SERVICETEKNOTES

Published by Tektronix Sales & Service Publications

TABLE OF CONTENTS

AM503A: Battery Backup Error (Pullout A)

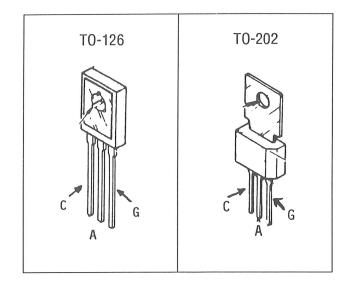
It has come to our attention that several units have been released to the field that have a problem with the battery backup circuit. This could cause the battery low indicator on the front panel to illuminate. Two components on the Main board need to be swapped to insure that it operates properly.

To keep the manual schematic correct, A1CR130 and A1R132 should be swapped. Circuit board orientation of A1CR130 will have the cathode going to the square pad from where A1R132 was located. See *Pullout A* for component nomenclature and location changes. Also the battery, A1BT130 P/N 146-0087-00, should be replaced.

After the two components have been swapped, and the battery replaced, the cal constants must be reinstalled in NVRAM. Refer to page 6-28 of the service manual to run test numbers 97 and 99 for the procedure.

DC503A: Transistor Part Number Changed Due To Availability

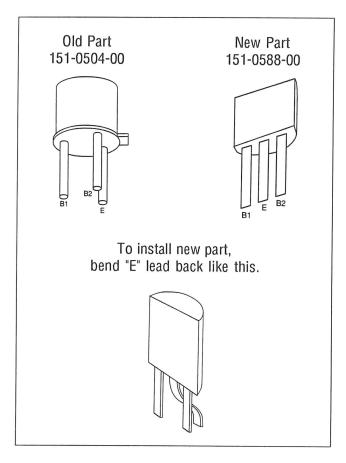
A14Q1300 in the Measurement Cycle Timing circuit, Schematic 5, has changed from a uni-junction transistor (P/N 151-0504-00) to a thrysistor (P/N 151-0588-00). A replaceable parts kit is available as P/N 050-2854-00. The kit should be ordered upon failure of the affected part.

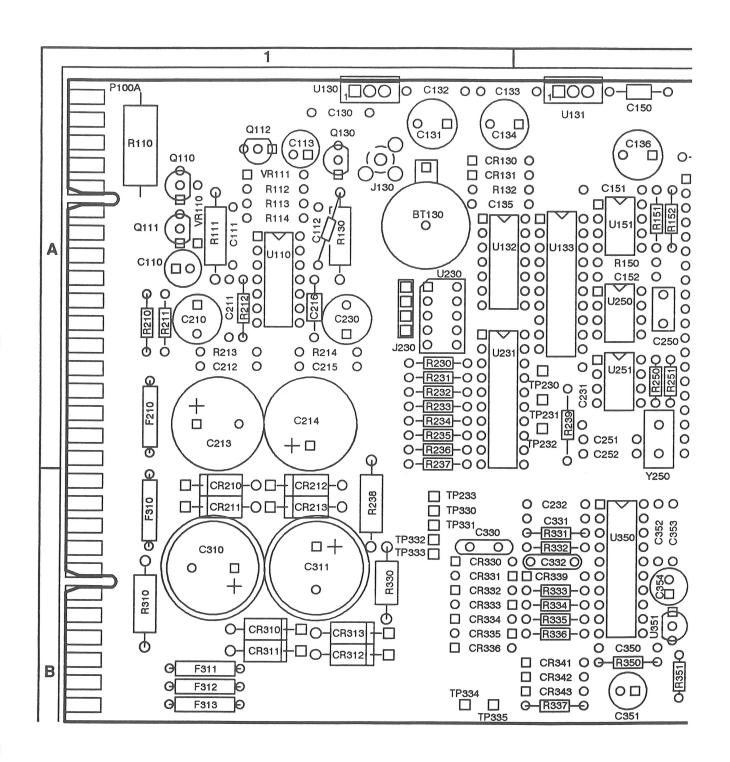
- During a calibration cycle, an error message would indicate that calibration of the L+R, L-R, L or R signal could not be completed.
- After a successful calibration, with monophonic signal components present in a BTSC broadcast signal, L, R, and L+R would not match.
- After a successful calibration, with stereo signal material having balanced audio levels present, L and R signals would not match on average.

The solution for this fault will be to install parts kit 050-2920-00. This kit contains four new capacitors and appropriate installation instruction.

Setup to Check Vertical Gain

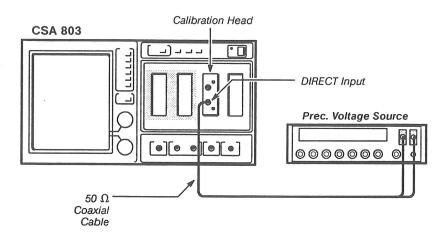
Step 10: Change the polarity of the voltage differential coming from the precision voltage Source. Check that the Δ Mean value is between -7.8 m and -8.2 mV.	V
Step 11: Refer to Table 2-3 and check actual results against the table specifications for the setting levels indicated.	
Note: Specifications are percent of full scale at each volts/div setting. Example: at 5mv/div full scale for 10 div is 50 mV, which gives an upper and lower spec tolerance of +0.5mV and -0.5mV.

Standard Setup to Examine/Adjustment Step Response

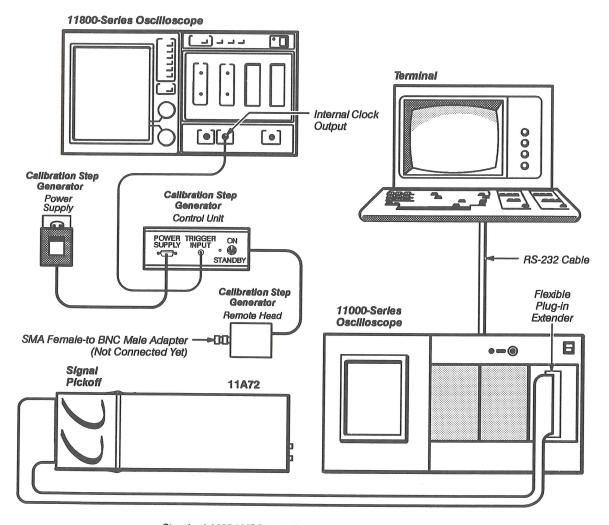
Add the following information to Checks and Adjustments, Part 6 Step Response.

Setup to Check Vertical Gain

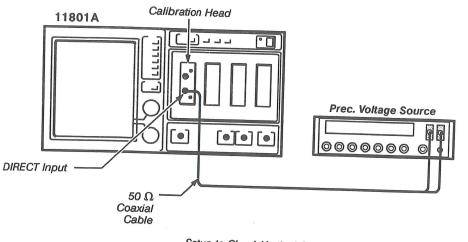
Step 4: Identify the trace as follows:
Def Tra icontouchIdentify Channel (2)touchSelect Enter Desctouch
Step 5: Set the mainframe Vert Offset as follows:
Vert size icon touch Set Vert Size:M2 to 2 mV/div dial / upper knob
Step 6: Set Averaging as follows:
Acquire Desc (in major menu) touch Average N (in pop-up menu) touch
Step 7: Select the Mean Measurement as follows:
MEASURE button
Step 8: Set the Voltage source to 8 mV.
Select Remove/Clr Trace (in major menu) touch Select Clear Trace (in pop-up menu) touch
Step 9: Wait for averaging to complete. Then, check that the \triangle Mean value is to be within 7.8 mV (lower spec) and 8.2 mV (upper spec).
Note: Averaging will complete faster if you exit the measurement menu and then return when averaging is complete. Alternatively, use the dial to move the Main Size setting two notches higher than the default setting.
Step 10: Change the polarity of the voltage differential coming from the precision voltage Source. Check that the Δ Mean value is between -7.8 mV and -8.2 mV.
